ADDENDUM TO BID DOCUMENTS

Ventura Unified School District

ATLAS Classrooms 2 and 3 Conversion:

Addendum 1
DATE: March 28, 2022

1 1/2" = 1'-0" (17)

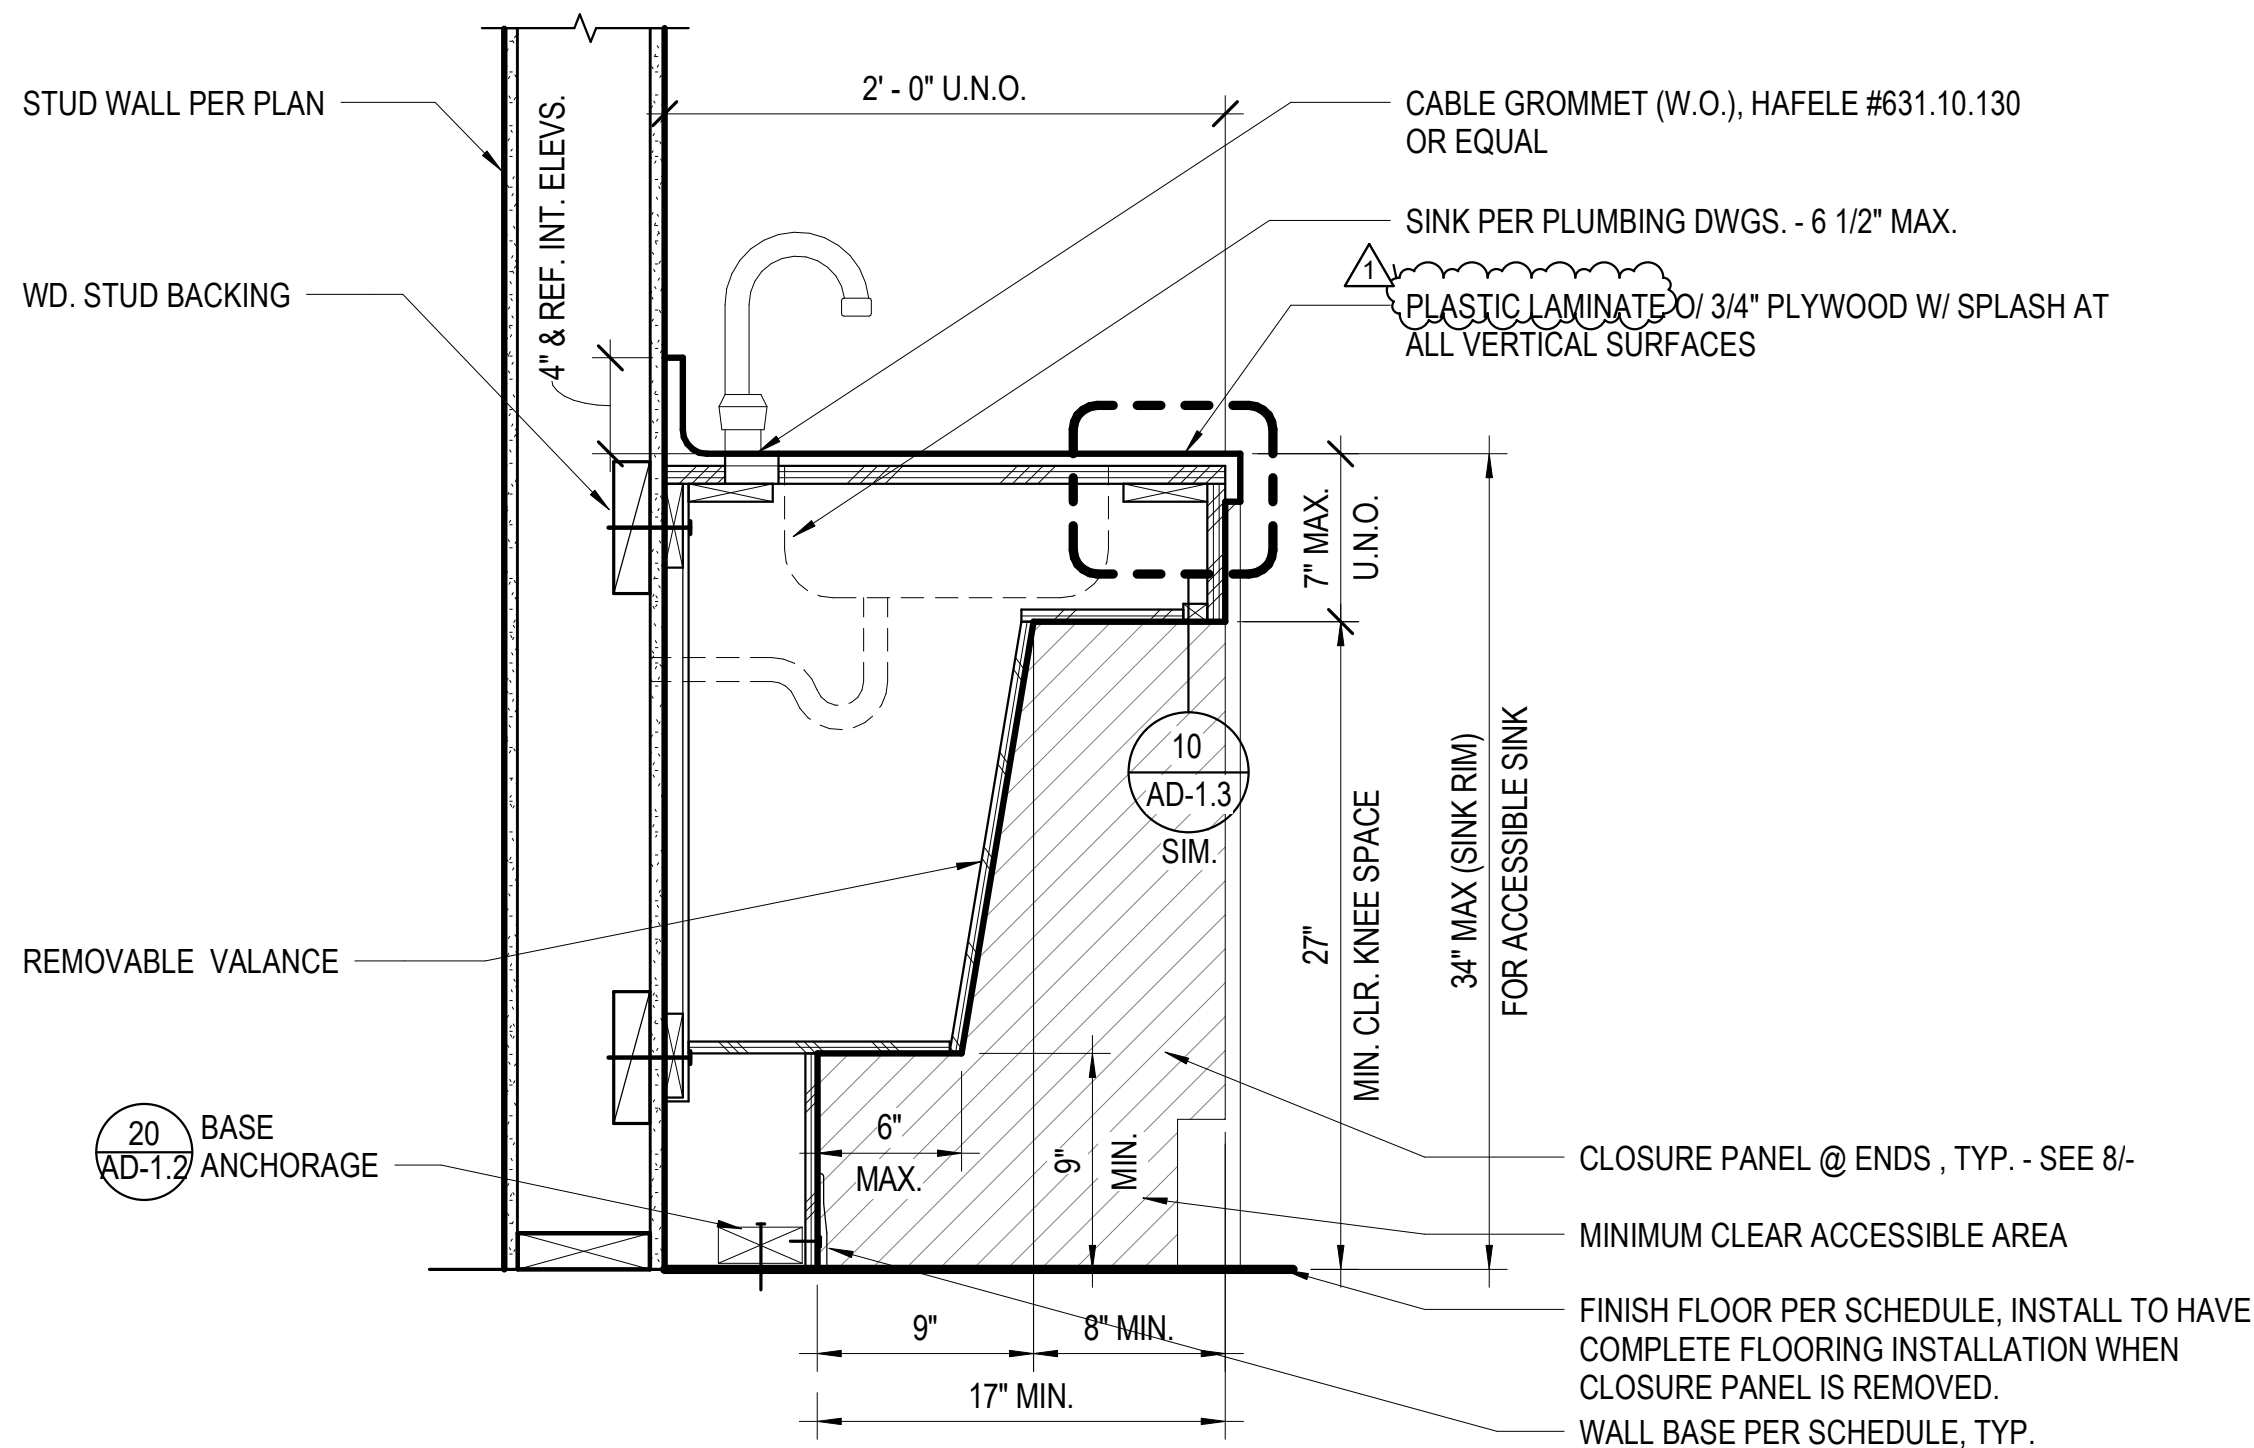
Item 6: Sheet AD-1.3 TYPICAL CASEWORK DETAILS

- Updated detail 17 to specify plastic laminated countertops.

RFI #012**Question:**

AD-1.3 - Detail 17 calls for solid surface counter top at sink locations, please provide spec.

Answer:

All countertops to be plastic laminated countertops. Detail 17 on sheet AD-1.3 revised.
